Metropolitan Branch Trail Upgrade

Preliminary Design Report
May 2023

Appendix A: Existing Conditions Plans
Appendix B: Stakeholder Meeting Summaries
Appendix C: Preliminary Design Plans
Appendix D: Preliminary Construction Estimate
Appendix E: Preliminary Agency and Community Comments, Responses
Appendix F: Stormwater Management Calculations

ROADWAY PLAN			
SCALE	1"=20'	DATE	MAY 2023
CONTRACT NO.	21-093-TLC		
DESIGNED BY	AMA	COUNTY	MONTGOMERY
DRAWN BY	MEG	LOGMILE	
CHECKED BY	RJG		
F.A.P. NO.	T.B.D.		
DRAWING NO.	HD - 01	OF	06
SHEET NO.	05	OF	16

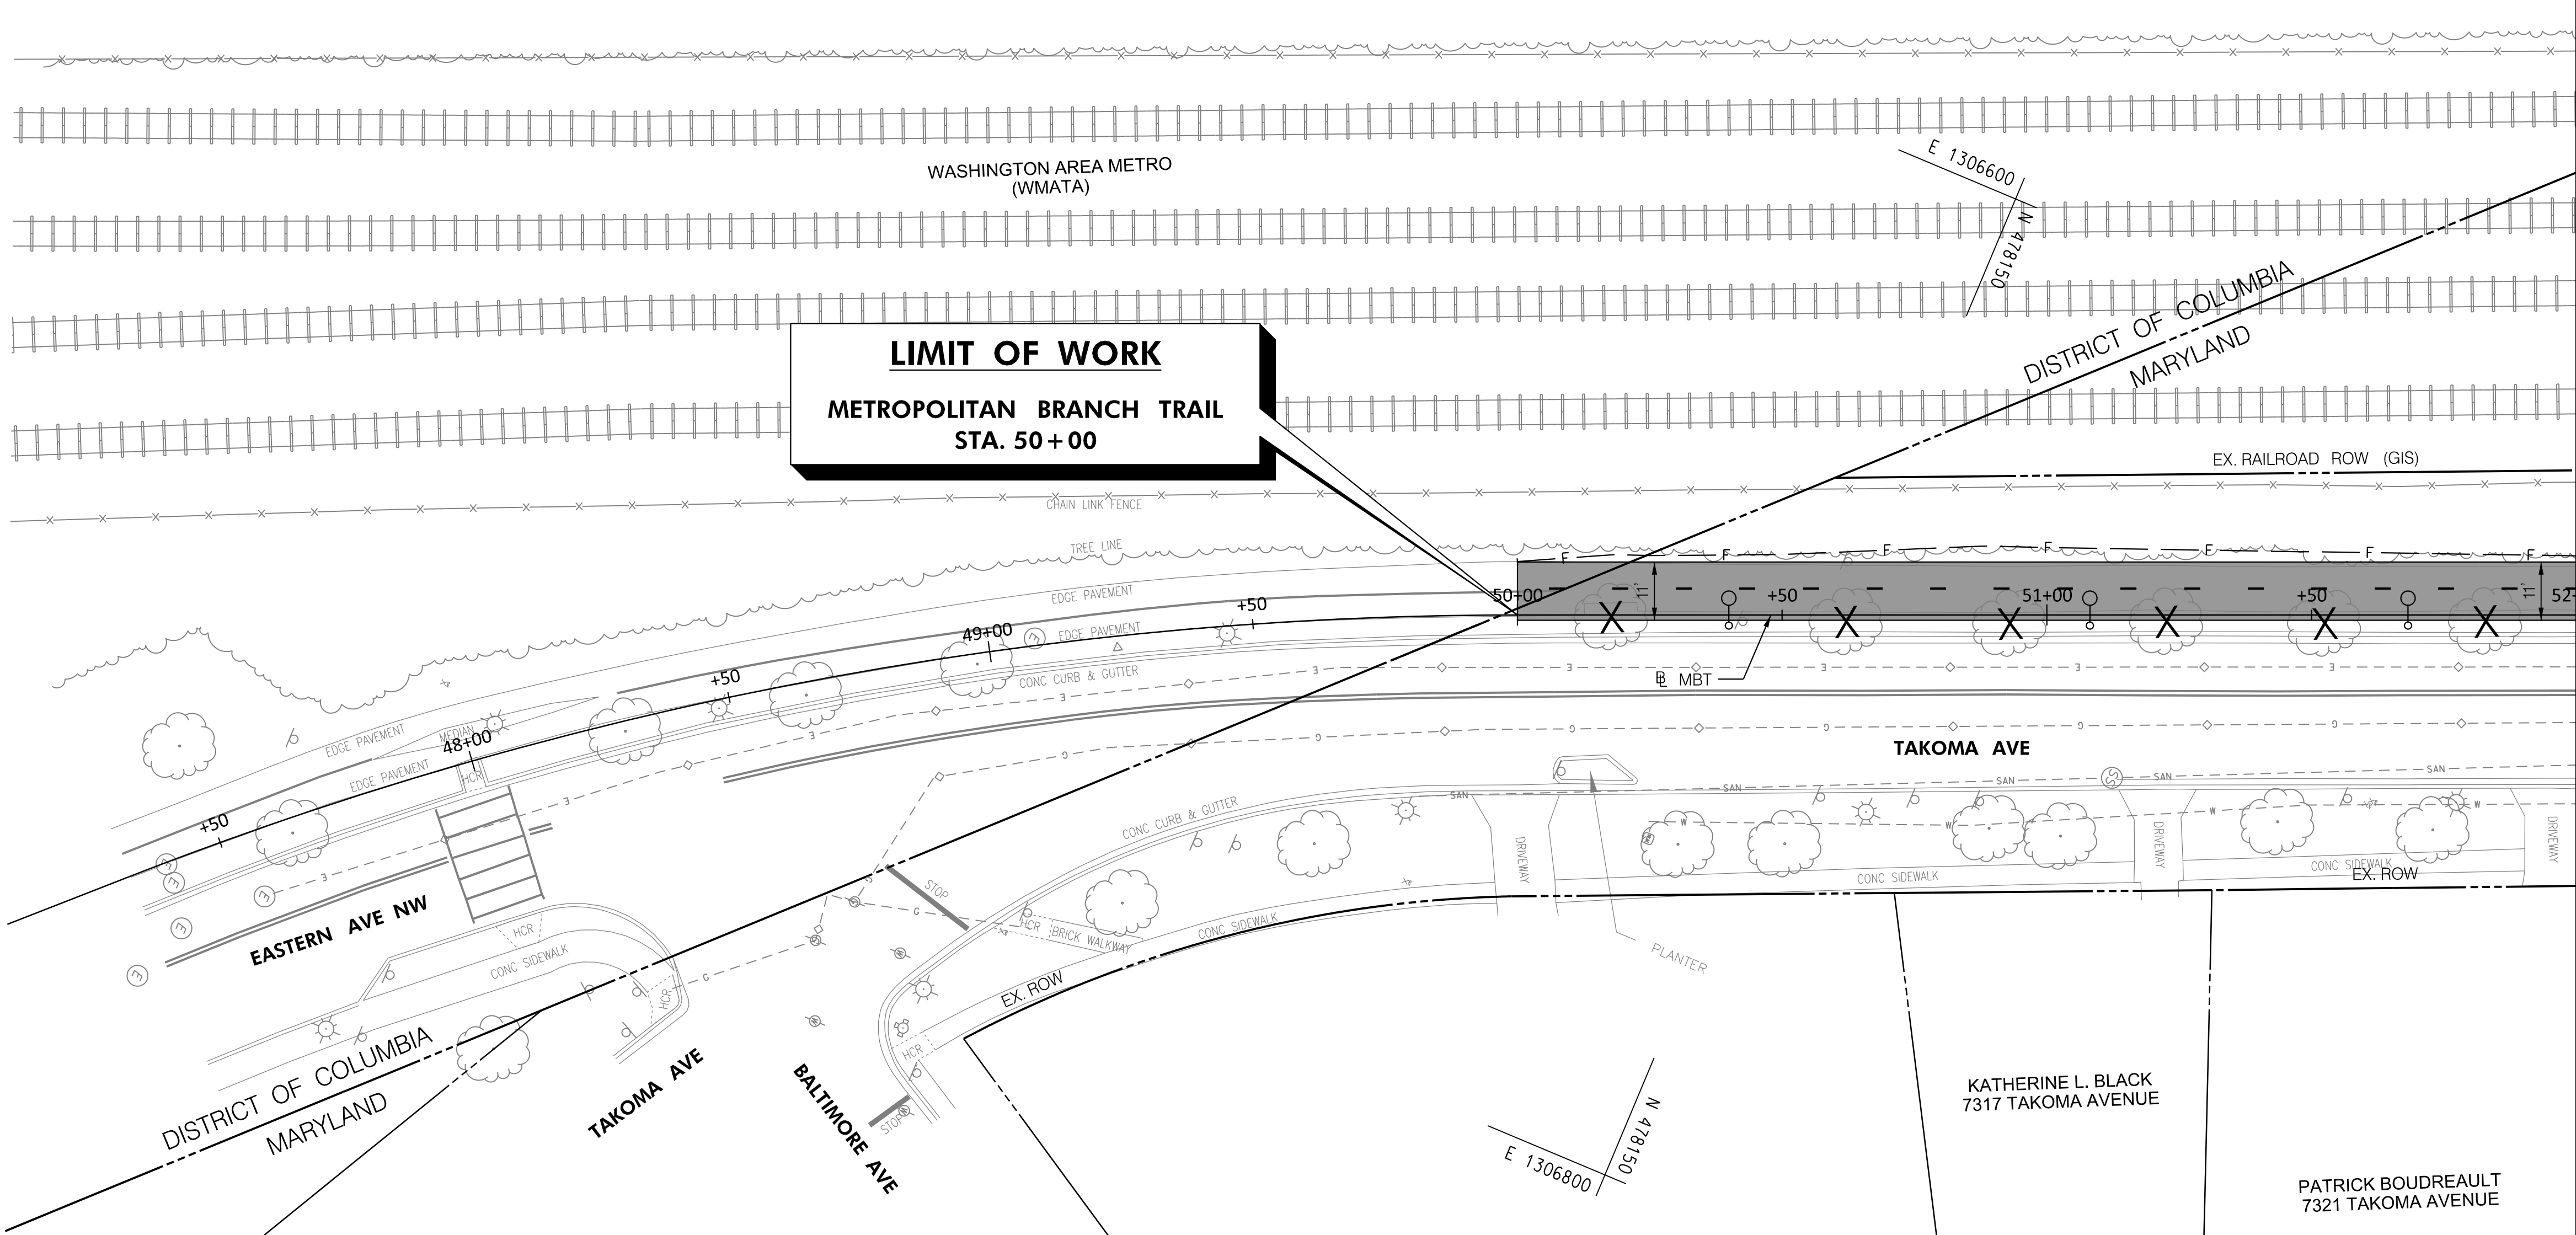
Project:	Takoma COGTLC Metropolitan Branch Trail		
Date:	April 2023		
Reviewer:	City of Takoma Park		
Comment ID	Sheet No. / Drawing No.	Comment	Response
1	HD-01	Public Works expressed concern that having these 'lights' so close to the road invites costly damage from when vehicles bump or collide with them. Would the design work such that they could be placed on the interior? Does that make sense? To me it seem that with the trees, it would be way less likely to happen and they add a note of physical protection to the trail?	It is recommended lighting remains in location shown to avoid unnecessary tree impacts on the opposite side of the trail. Proposed curb will provide protection from vehicles colliding with them.
2	HD-01	Although there is a lot of public feedback in support of porous pavement, PW staff and M-NCPPC staff we spoke with feel strongly that a more durable surface, like asphalt, will be easier and more cost-effective to maintain over time. Apparently it also better aligns with the County's standards for "Regional Breezeways", which this trail has been identified as.	Will use asphalt surface for shared use path.

SCALE	1"=20'	DATE	MAY 2023	CONTRACT NO.	21-093-TLC
DESIGNED BY	AMA	COUNTY	MONTGOMERY		
DRAWN BY	MEG	LOGMILE			
CHECKED BY	R/JG				
F.A.P. NO.	T.B.D.				
DRAWING NO.	HD - 04	OF	06	SHEET NO.	08 OF 16

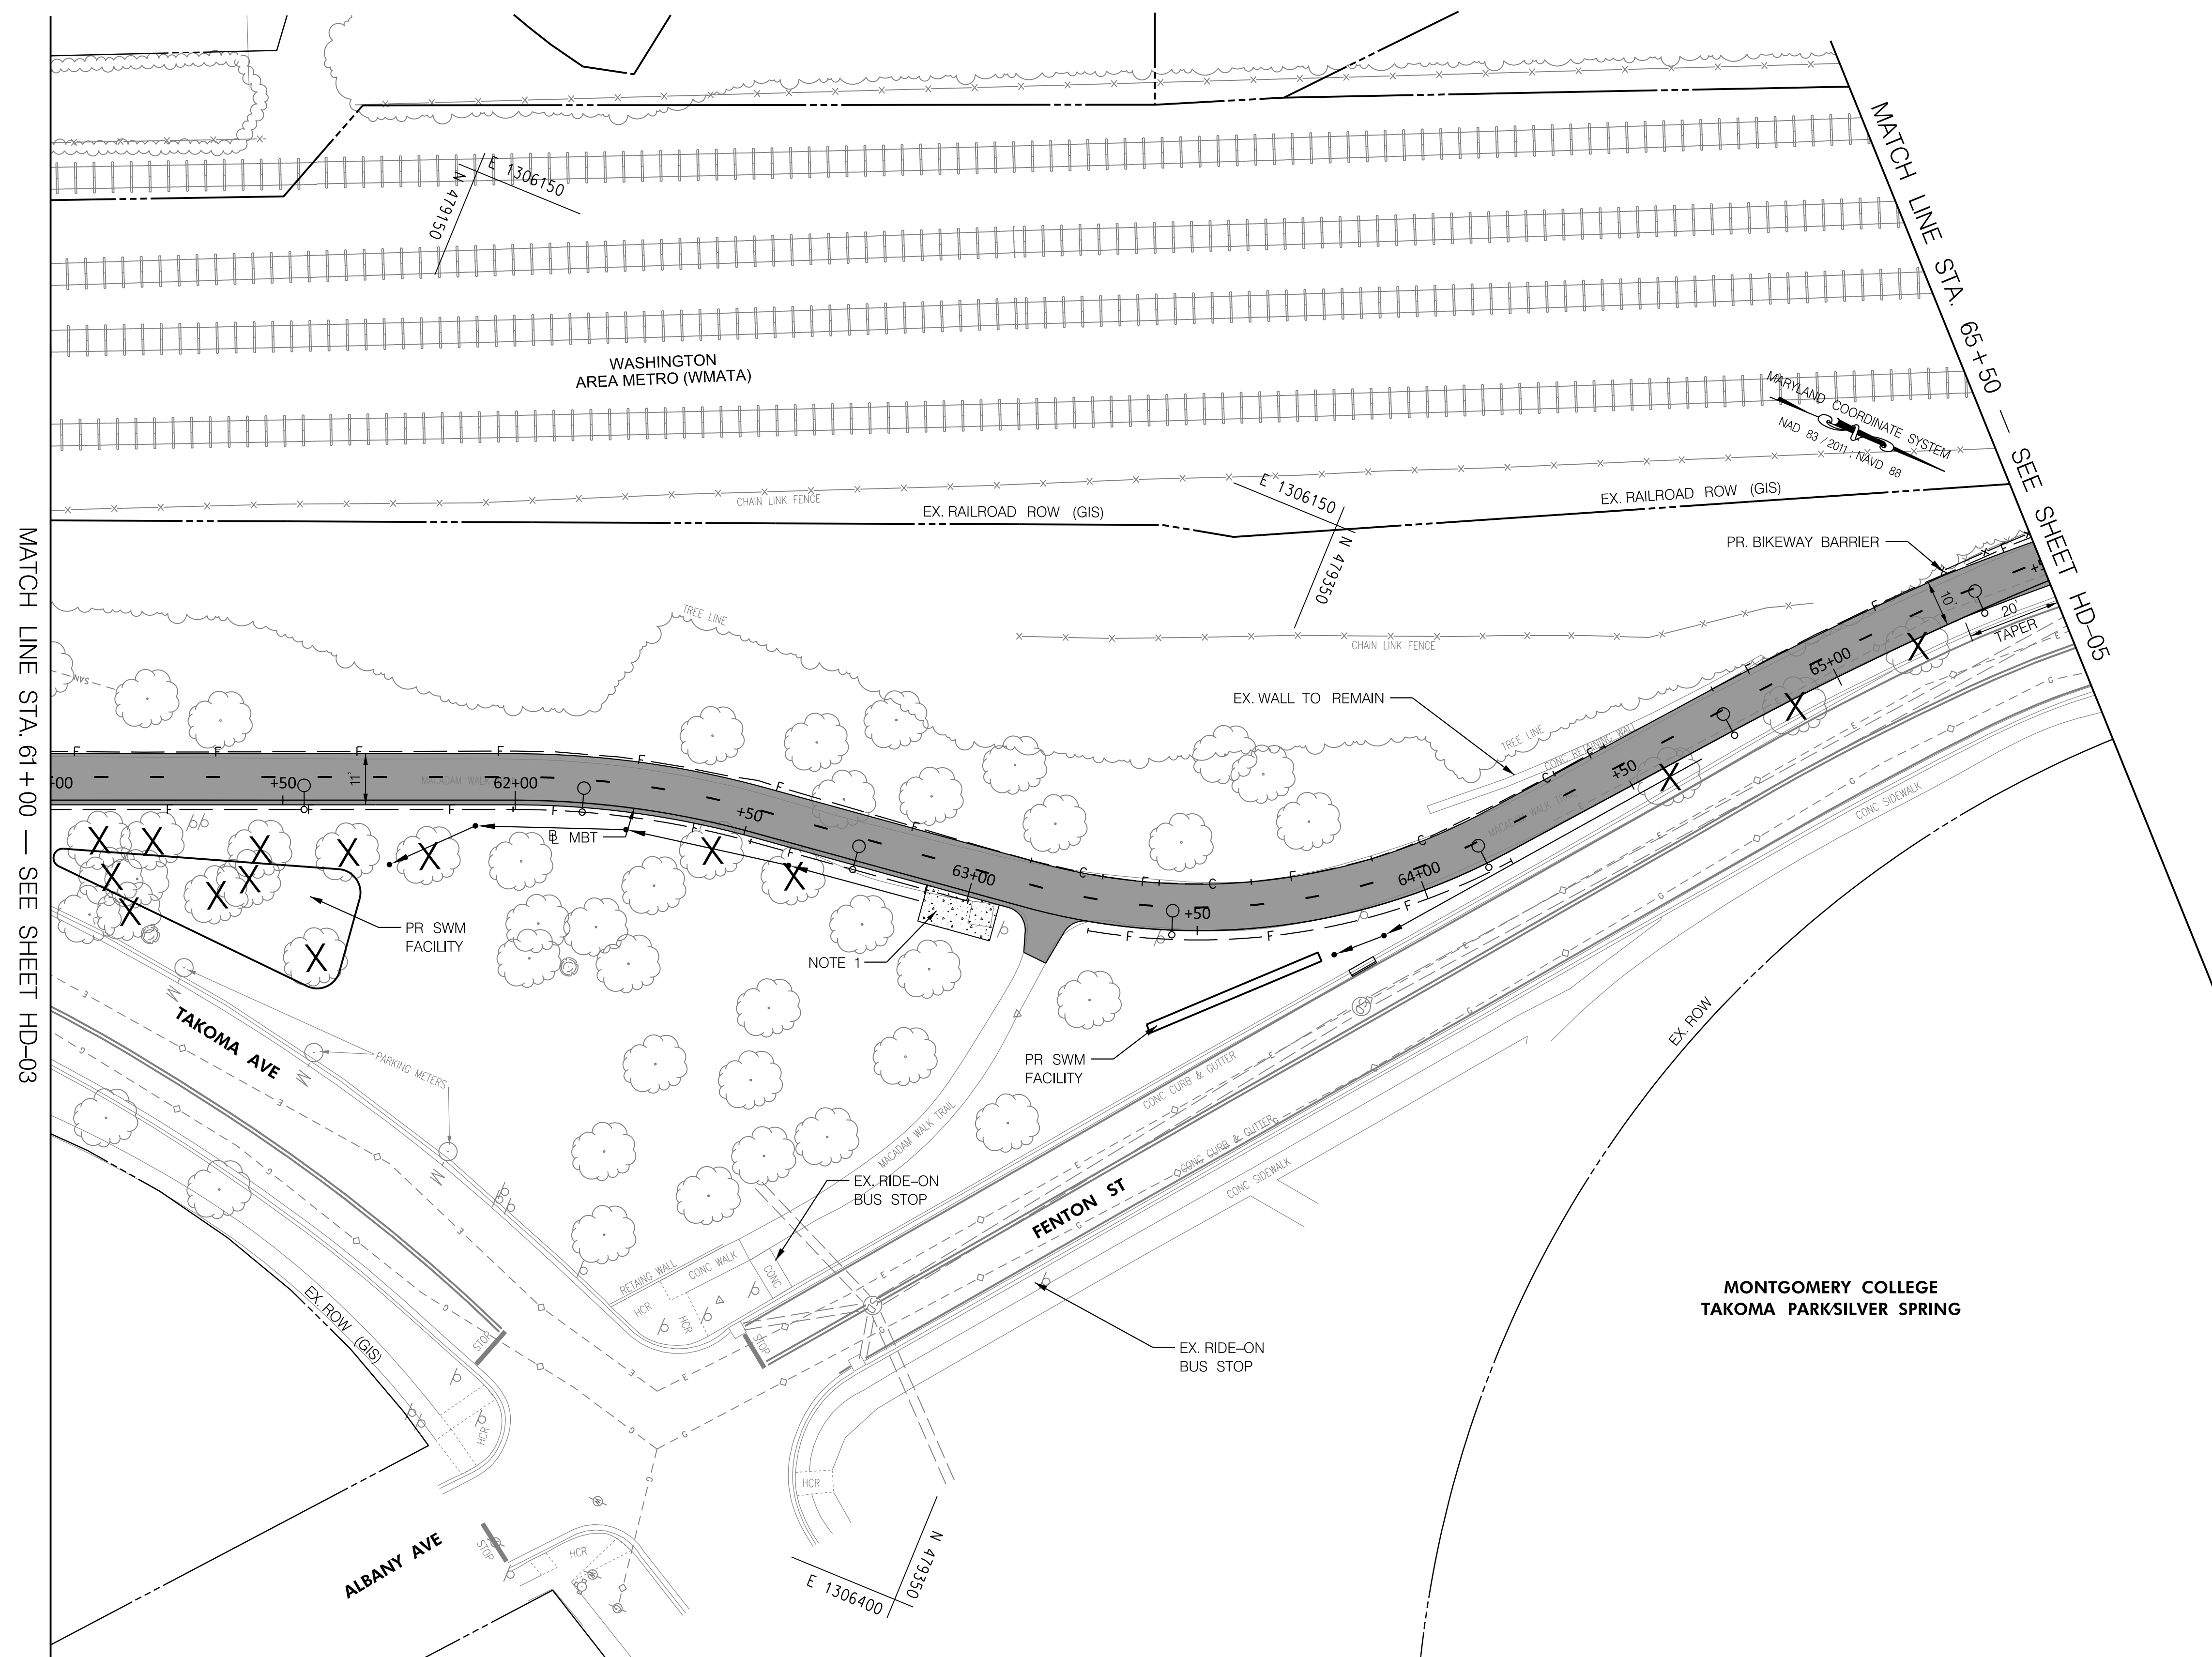
7	HD-04	I also recommend the striping of four-quadrant crosswalks at the intersection of Fenton Street & Takoma Avenue, though I realize that may be out of scope.	This work is outside the scope for this project. Will record comment for future design stages.

SCALE	1"=20'	DATE	MAY 2023	CONTRACT NO.	21-093-TLC
DESIGNED BY	AMA	COUNTY	MONTGOMERY		
DRAWN BY	MEG	LOGMILE			
CHECKED BY	RJG				
F.A.P. NO.	T.B.D.				
DRAWING NO.	HD - 05	OF	06	SHEET NO.	09 OF 16

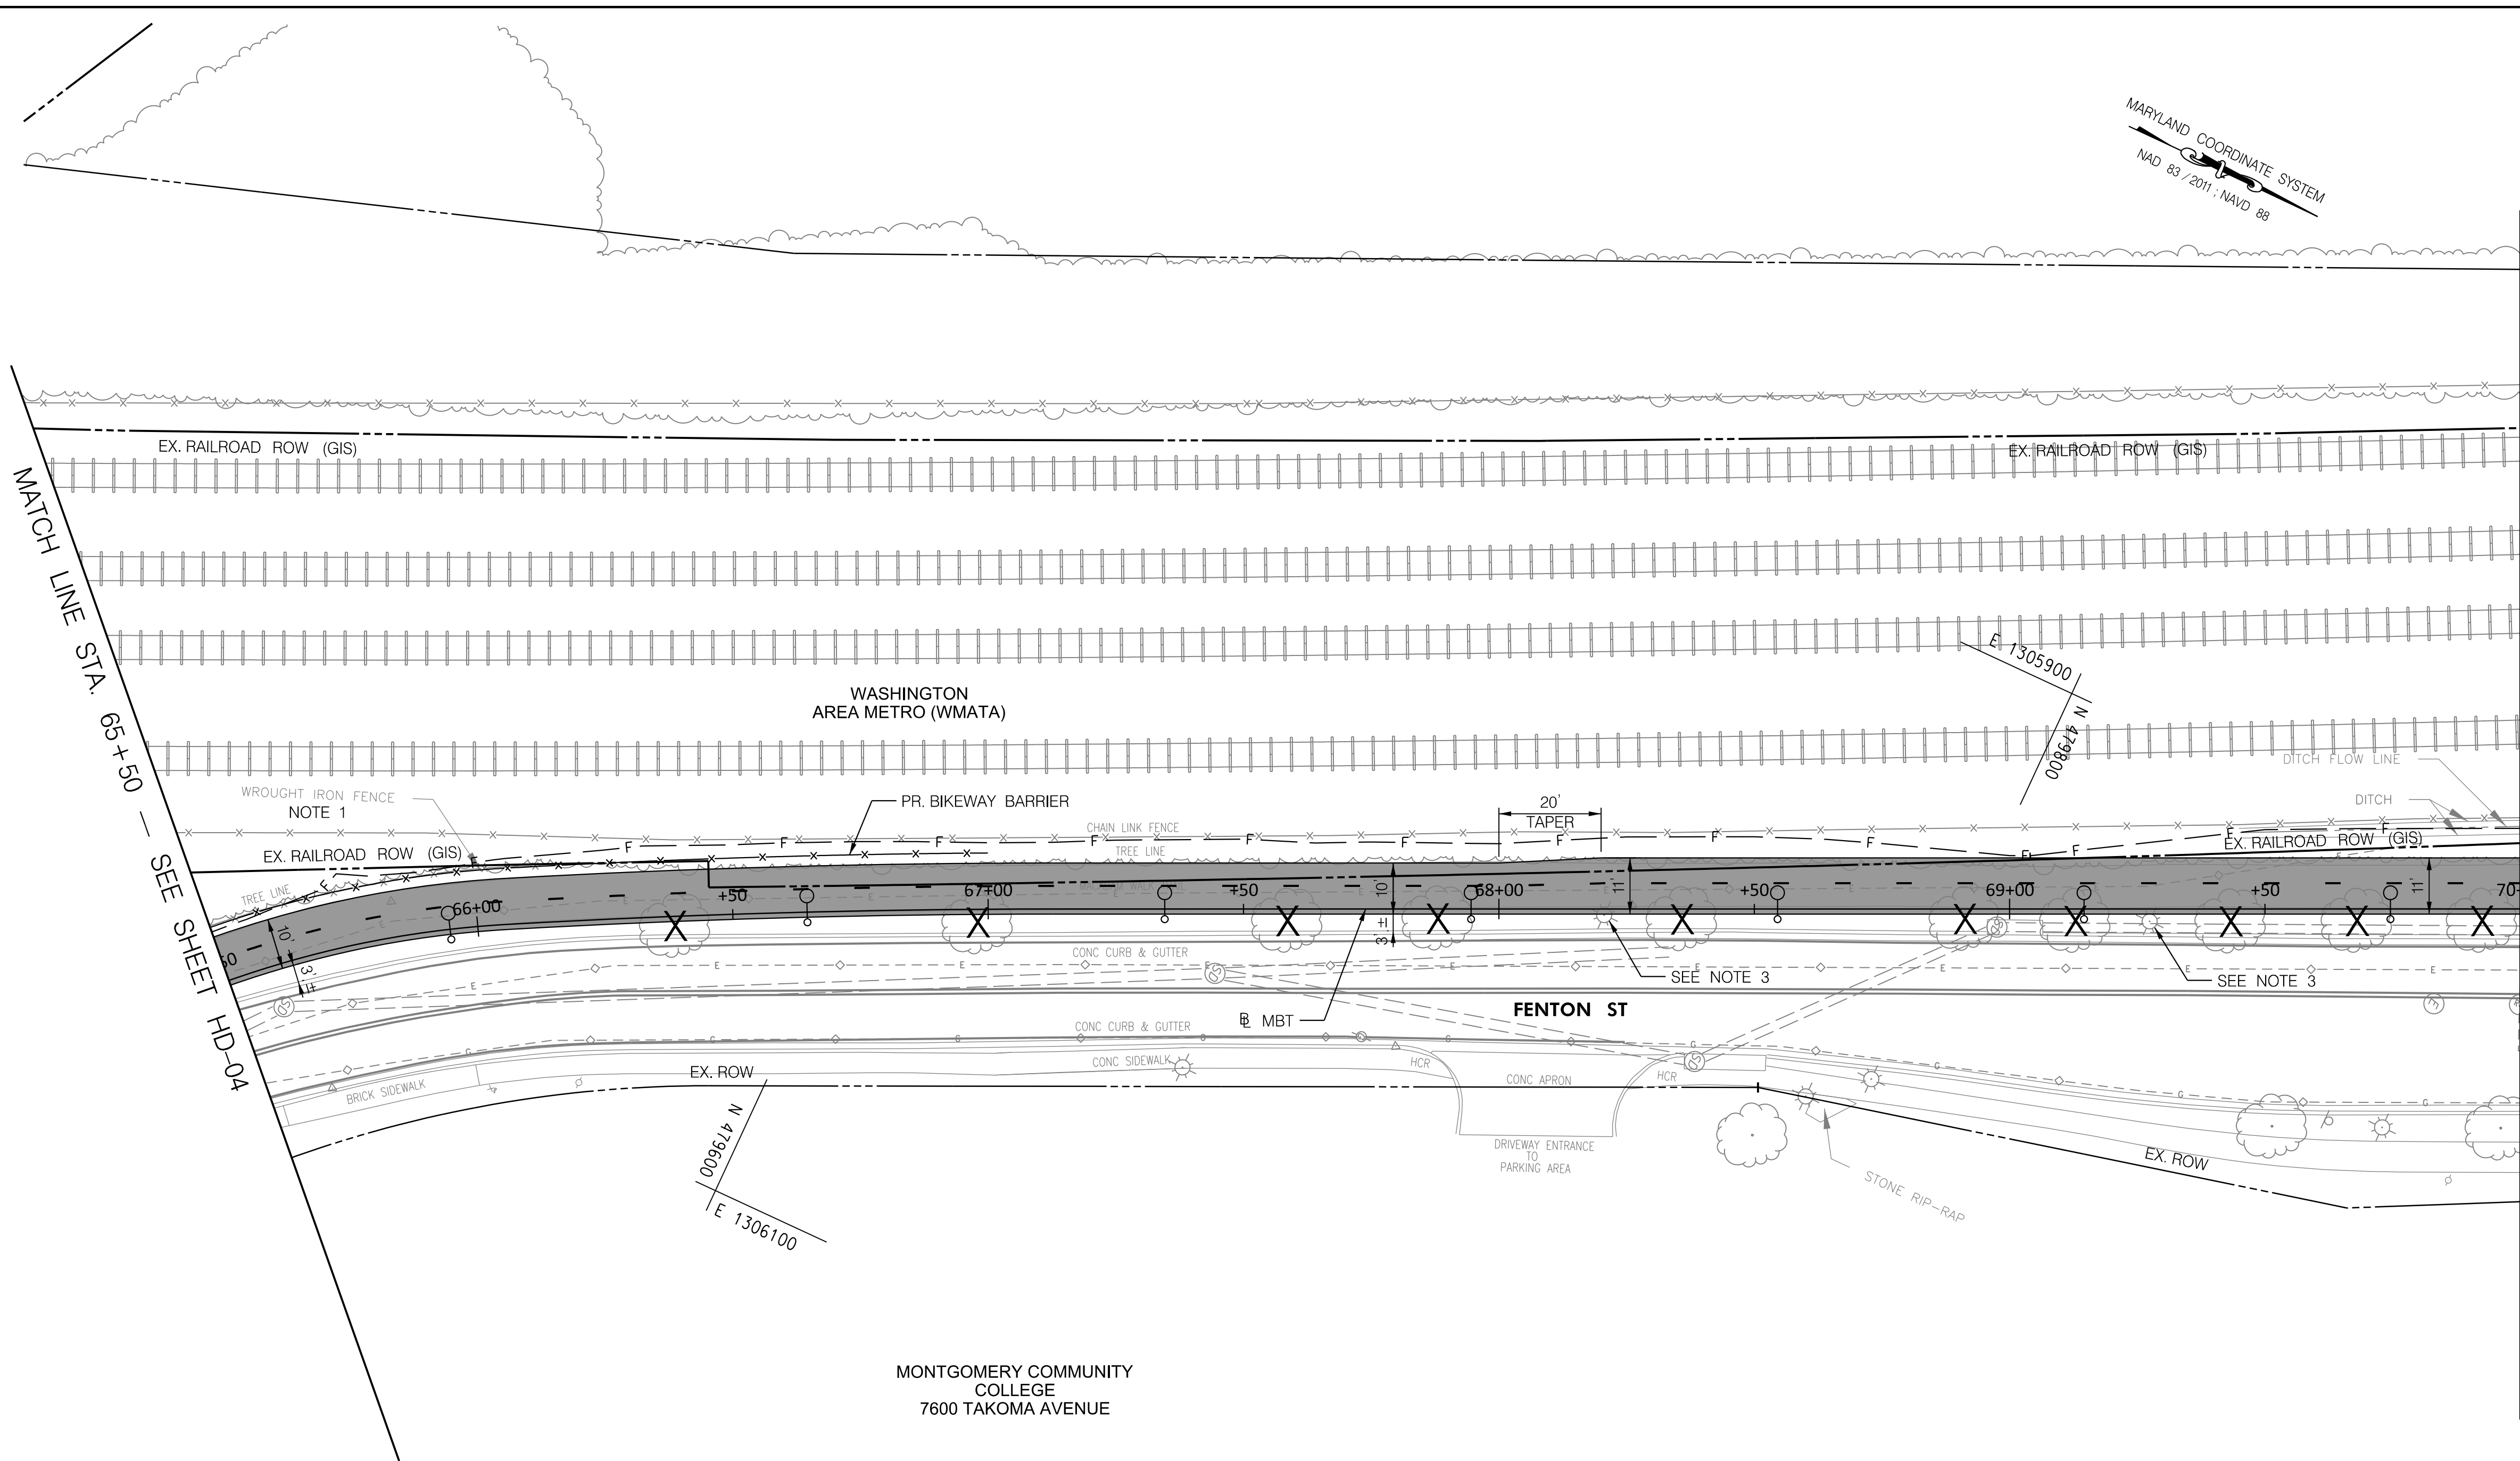
9	9	<p>Previous sheets note that tree impacts/conditions will be evaluated at a later stage, however trees on this page are proposed for removal at this time. Please clarify the reason for this inconsistency.</p>	<p>Notes have been revised. A tree condition assessment will be performed for the next phase of design for all trees. Tree removals shown on the final 30% plans (Appendix C) are street trees that will be impacted due to the design request by the City and M-NCPPC to widen the trail to 11 feet (minimum) and to use standard asphalt pavement for the trail. Also, the City arborist said the street trees on the east side of the trail are mostly Maples, which have a more aggressive shallow rooting habit that is more likely to create pavement heaving conflicts.</p>
10	General	<p>Although further details will be confirmed at a later stage, please provide as much expected environmental information in the proposal as possible (tree protection measures, tree removals, supplemental/replacement planting, swm, any master plan recommendations, etc).</p>	<p>Comment noted. Tree protection measures and removal details will be provided during subsequent design phases. Conceptual SWM is provided on the 30% plans.</p>
